WEST CULBURRA MIXED USE SUBDIVISION

West Culburra Concept Development Proposal-
SSD 3846

WEST CULBURRA MIXED USE SUBDIVISION RESPONSE TO EIS-SSD 3846 SITE & LOCATION

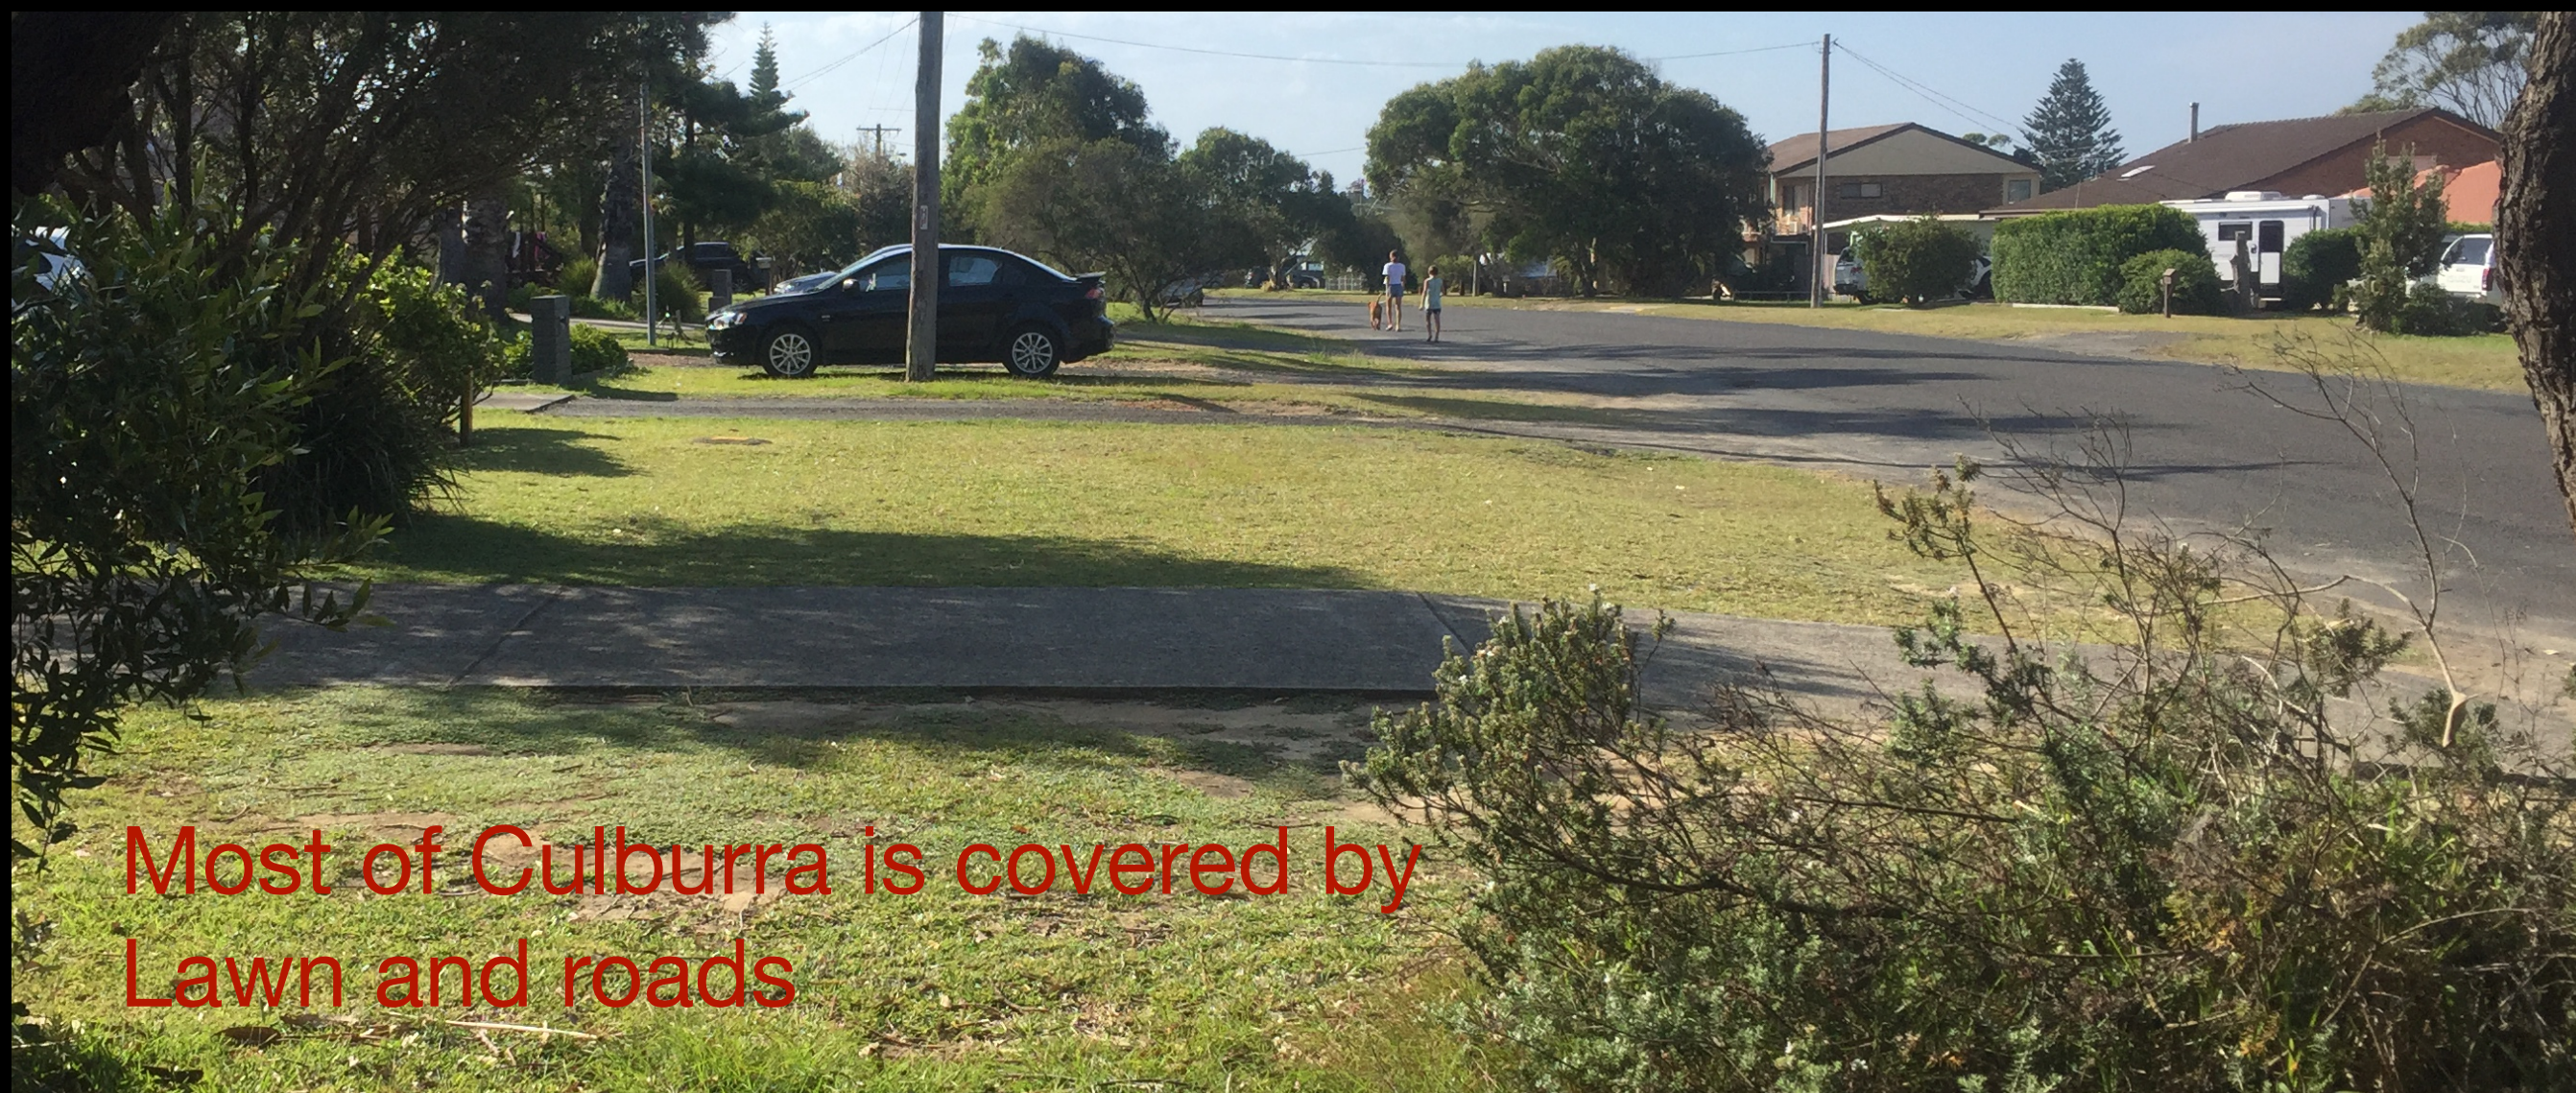
After decades of discussions, controversies and denials this has now been acknowledged as a REAL problem, technical solutions have been addressed in the EIS and should be further enhanced in any DCP to include Planting and its effect.

Most estates are covered by Lawn which removes CO₂ but it also produces CO₂ creating a neutral effect. This does

**CARBON CAPTURE HAS THE MAJOR EFFECT ON
GLOBAL WARMING** and design principles must be
incorporated in any LEP & EIS

The areas of Lawn in new estates should be limited.

Most of Culburra is covered by
Lawn and roads

It could look
like this

Shrubs and trees are more effective than lawn and create a better PARKLAND image
